PHILADELPHIA ELECTRIC COMPANY

Subject: US NRC Concerns Regarding Adequacy of Design
Margins of Mark II Containment Systems

Docket Numbers 50-352
50-353

ISSUE 4.7: RELATIVE POSITIONS OF RHR SUCTION AND DISCHARGE

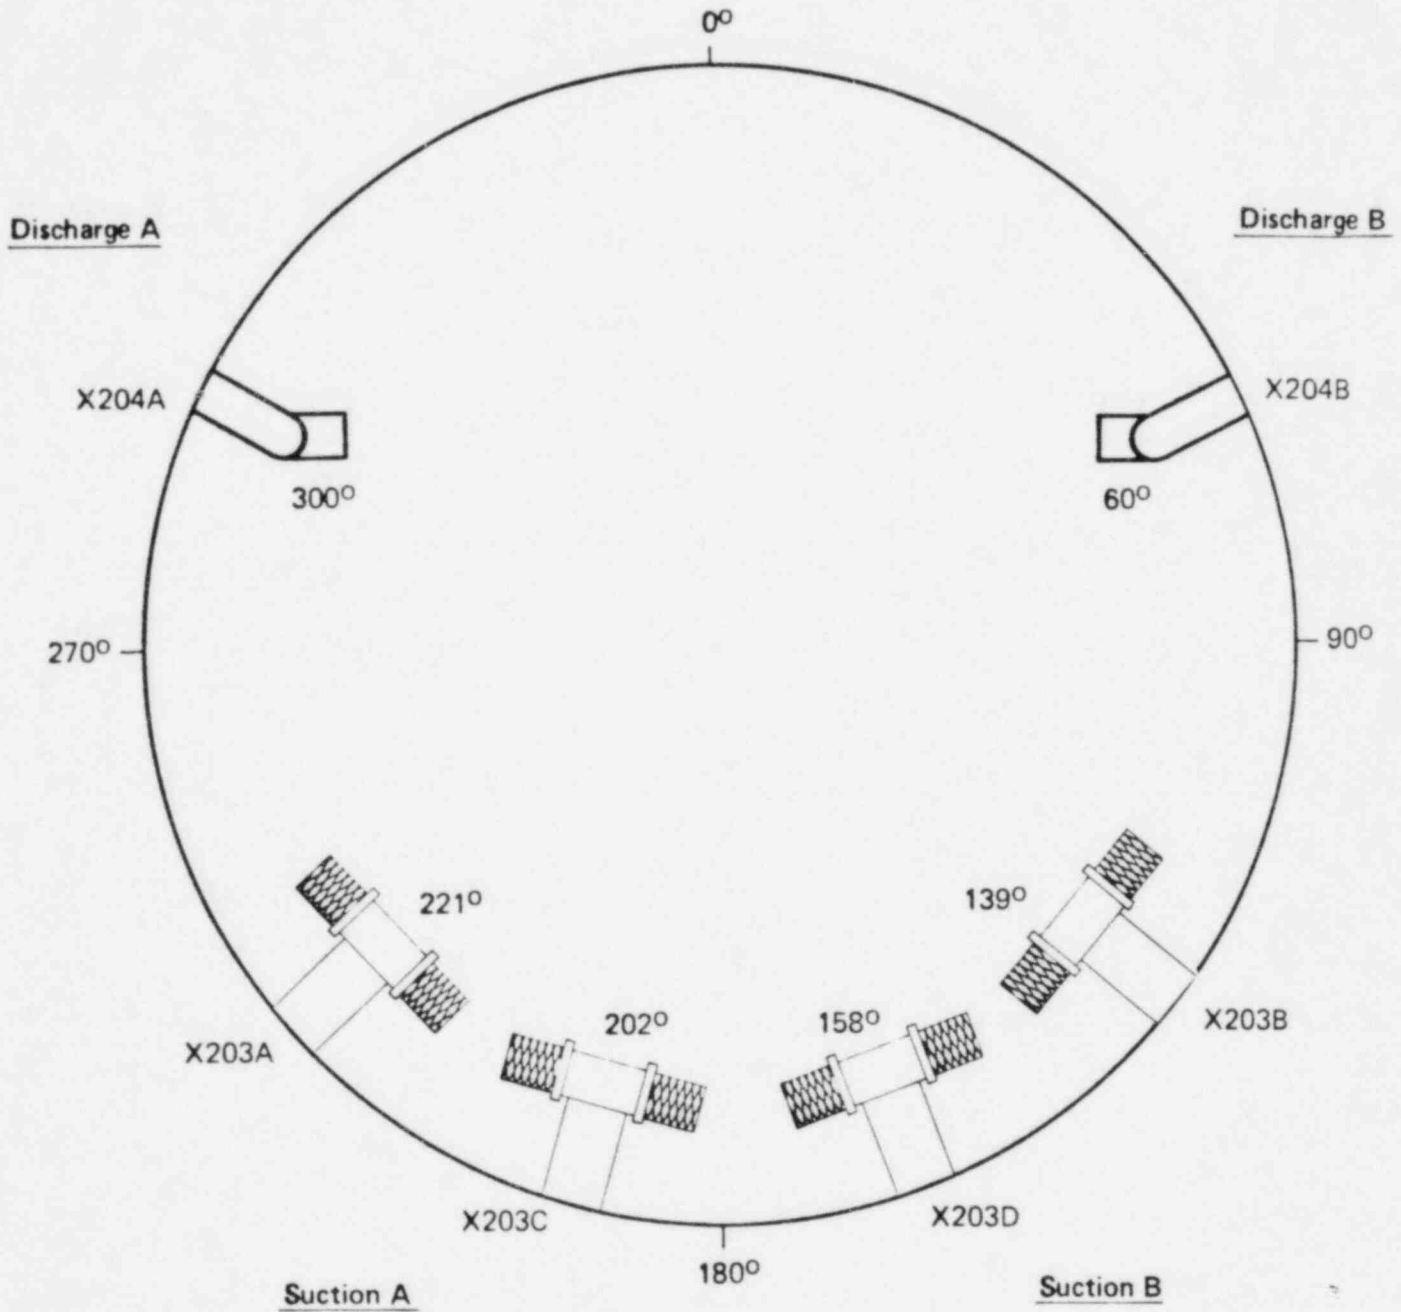
- 4.7 All analyses completed for the Mark III are generic in nature and do not consider plant specific interactions of the RHR suppression pool suction and discharge.

4.10 Justify that the current arrangement of the discharge and suction points of the pool cooling system maximizes pool mixing.

Response

There will be no adverse interaction of the Limerick pool cooling suction and discharge. The suction and discharge of both RHR loop "A" and loop "B" have an adequate radial separation of approximately 80°. All suctions are located about 10 feet above the basemat while the discharges are located about 18 feet above the basemat. Additionally, each discharge includes an elbow to direct flow away from the associated suctions.

The sketch on the following page shows the relative positions of Limerick's RHR suctions and discharges.

RHR DISCHARGE: PENETRATION AT ELEVATION 219'
DISCHARGE AT ELEVATION 199'-11"
RHR SUCTION STRAINERS: PENETRATION AND SUCTION AT ELEVATION 192'
BASEMAT ELEVATION: 181'-11"

As described in the response to Issue 4.7, the current arrangement of the RHR discharge and suction points will provide adequate pool mixing.
